DEVIATION REQUEST AND DECISION FORM

Project Name :	Crossroads North
Schedule No.(s) :	5408001008, 5408001029, 5408001032, 5408001033, 5408001034, 5408001041, 5408001042, 5408001050, 5408001051, 5408001052
Legal Description :	Lots 12, 13, 14, 15, 16 and 18, Hillcrest Acres, according to the plat thereof recorded May 12, 1960 at reception No. 153860, except that portion acquired by the department of Transportation, State of Colorado as described in rule and order recorded April 28, 2004 under reception no. 204068322, and except those portions conveyed to El Paso County by and through the Board of County Commissioners of El Paso County, Colorado by special warranty deed recorded December 17, 2014 at reception No. 214116021 and recorded December 17, 2014 at reception No. 214116022, County of El Paso, State of Colorado, Lot 17, Hillcrest Acres, County of El Paso, State of Colorado, except that portion conveyed to El Paso County by and through the Board of County Commissioners of El Paso County, Colorado by special warranty deed recorded December 30, 2014 at reception No. 214119767. Lot 19, Hillcrest Acres, County of El Paso, State of Colorado, as amended by surveyor's statement recorde

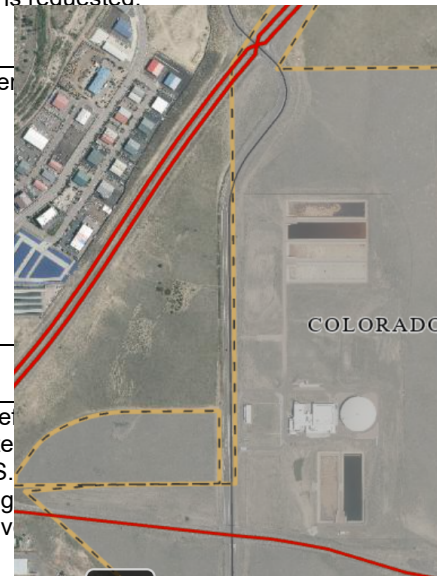
This request is likely to be denied since this is not in conformance with the approved Marksheffel Road Corridor Study Access Control Plan (ACP). The ACP identified the second access as a right-in/right-out only. Right now there is no sufficient justification why a RI/RO cannot be used. Additionally, approval of the deviation would require amending the access control plan, amending an IGA between multiple jurisdictions and BoCC approval of the amended ACP.

As previously discussed, one potential alternative solution is to petition to Annex Marksheffel Road to the City. The City may have a simpler process when it comes to approving access that is not in conformance with the ACP. If you look at the aerial snippet above the intersections to the north and south are already within the City.

CROSSROADS NORTH NORTH ACCESS CONFIGURATION EXHIBIT

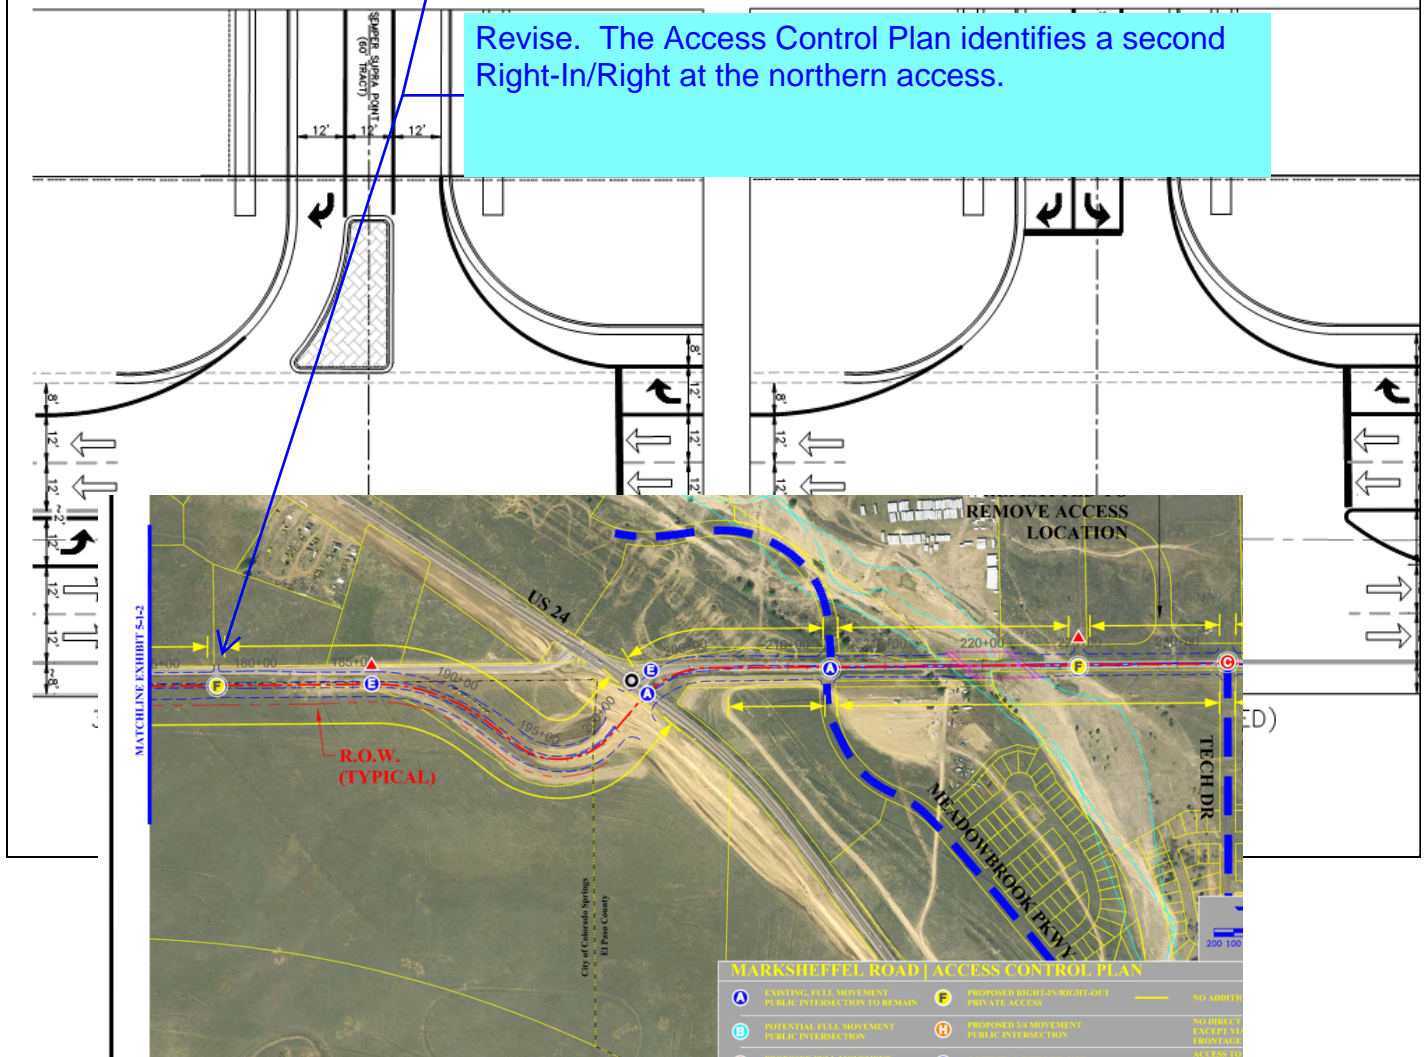
Revise. The Access Control Plan identifies a second Right-In/Right at the northern access.
